PZ&B Staff Combination Memorandum: Landmarks Preservation Commission and Town Council

SUBJECT: COA-24-0016 (ZON-24-0048) 102 JUNGLE RD (COMBO)

COA-24-0016 (ZON-24-0048) 102 JUNGLE RD (COMBO). The applicant, Ethanhill, LLC, has filed an application requesting a Certificate of Appropriateness for the review and approval of a beach access gate replacement requiring a variance to exceed the maximum height for the landmarked property. This is a combination project that shall also be reviewed by the Town Council as it pertains to zoning relief/approval.

Beach Access Gate

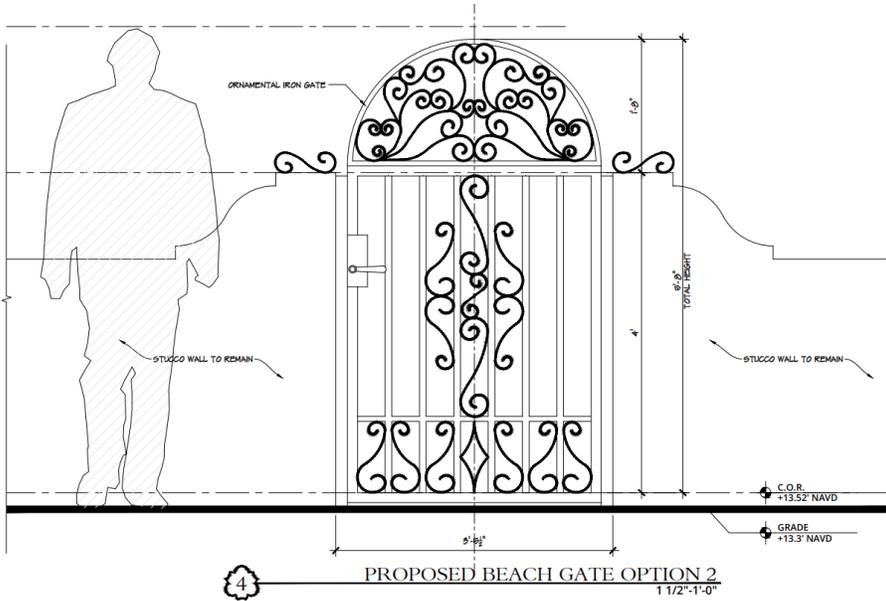
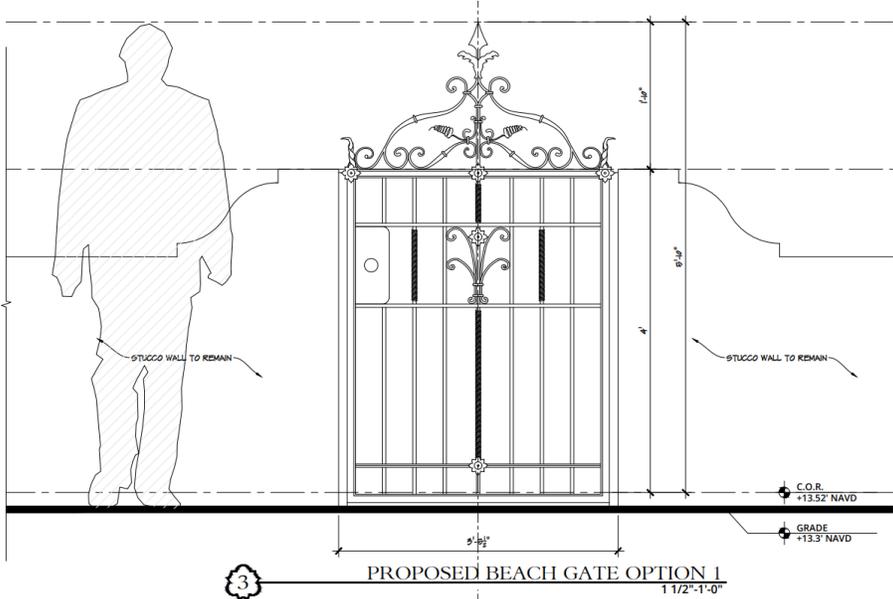
The application is seeking a Certificate of Appropriateness for the installation of a new beach access gate that requires a variance to exceed the maximum allowable height. The proposed gate would be constructed of iron and have decorative elements in both the swing portion as well as the decorative cap. Two options have been provided, one that has a more filigree point and the other with a rounded top. Decorative iron beach gates are common along South Ocean Boulevard and this would be consistent both in height and design. The arched top option would be a more typical approach. Both of the proposals draw their design inspiration from iron work found on the landmarked structure associated with this access point.

The current gate is made of diagonal wood pieces with flared stucco end caps leading to the sea wall. This gate matches the materials of an entry gate on the south side of the property.

The applicant has submitted two (2) options for a new beach access gate:

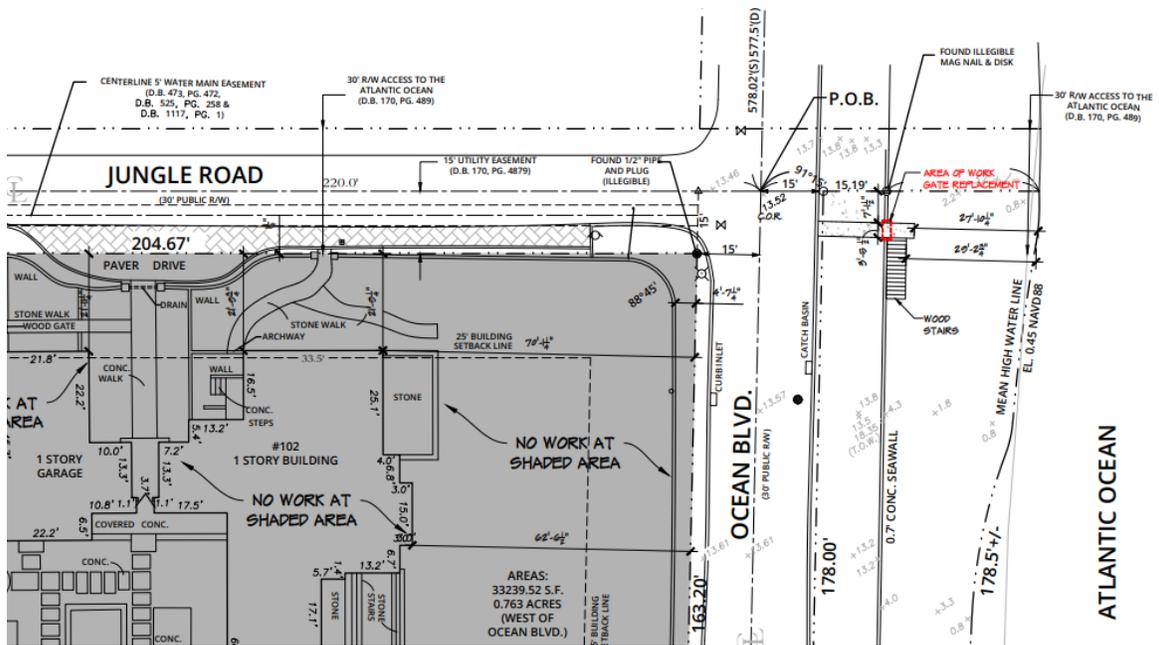
Since the proposed gate options exceed the maximum allowable gate height, a variance is required as outlined in the table below:

Code Section	Permitted	Option #1	Option #2	Variance
Variance #1: 134-1475(c)(1)	4'-0" Maximum Height	5'-8" Proposed Height	5'-10" Proposed Height	Range 1'-8" to 1'-10"
